25-229

A25-00229 Summary 11/11/03

1) Lombard Land / Livestock general Summary.

Waypoint 026

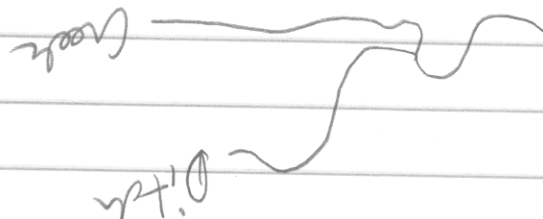
GPS 025 $\approx$ Where water goes under road

GPS 026 = POD 710,094 E ~~281~~

Lombard does allow some stockwater down creek
for Fish & Wildlife & Gene Lombard

Some may reach to Collins
